Application No.: 02119994.9	Department:	Date of Dispatch July 30, 2004
Applicant: CITIZEN ELECTRONICS CO., LTD.		
Title: CONDENSER MICROPHONE AND METHOD FOR MANUFACTURING CONDENSER MICROPHONES

THE OFFICE ACTION

The Text of the Second Office Action

图 10

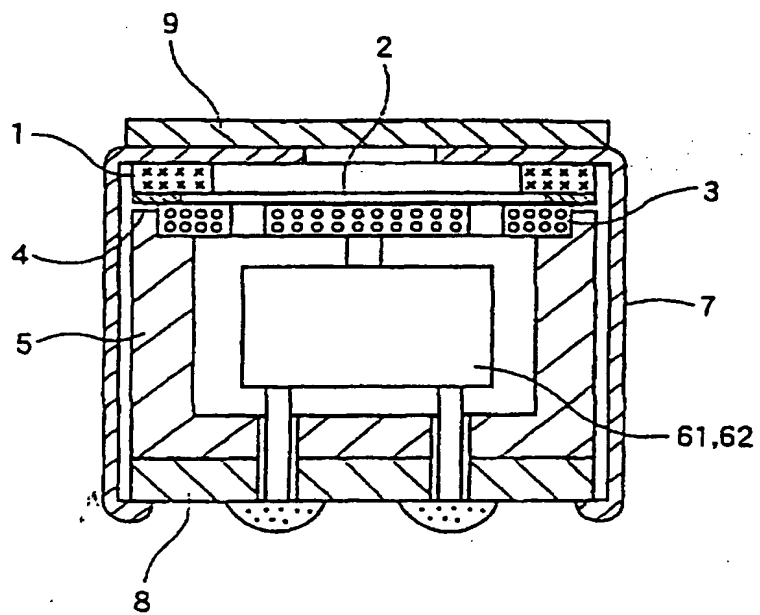
Claim 1 requests to claim a condenser microphone. Reference document 1 (CN1290998A) has disclosed a semiconductor electret condenser microphone widely used as digital portable telephones (corresponding to the condenser microphone of claim 1) and the following technical features (See lines 3 to 11 of page 1 of the specification and Figure 10): comprising a printed circuit board 8 (corresponding to the substrate of claim 1), a back electrode holder 5 for holding a back electrode 3 and fixed on the printed circuit board, a spacer 4 provided on the back electrode, a diaphragm 2 provided on the spacer, and a ring 1 having a sound exporting hole and adhered to the diaphragm.

It can be seen that the technical solution of claim 1 is different from that of D1 in that claim 1 further defines the back plate secured to the substrate with adhesive, the spacer adhesively secured between the back plate and the diaphragm electrode. However, although D1 does not definitely limit whether the adhesive is used between the back electrode holder 5 and the printed circuit board 8, between the spacer 4, the back electrode 3 and the ring 1, in order to obtain a securely strong connection between these members it is common technical means for the person skilled in the present field to use an adhesive to secure them, and there has been the adhesive between the ring 1 and the diaphragm 2 in D1, thereby it is very easy and can be conceived to apply adhesive between other members. Therefore, claim 1 does not have prominent substantive features nor represents notable progress over D1, not conforming to the provision of Item 3 of Article 22 of the Chinese Patent Law.

2. The additional technical features of claim 2 have been disclosed in D1 (See lines 3 to 12 of page 1 of the specification, Figure 10). In D1,

a recess in which wirings connecting the back electrode, the diaphragm and the printed circuit board is also provided on a side of the microphone. Therefore, claim 2 does not have inventiveness over D1, not conforming to the provision of Item 3 of Article 22 of the Chinese Patent Law.
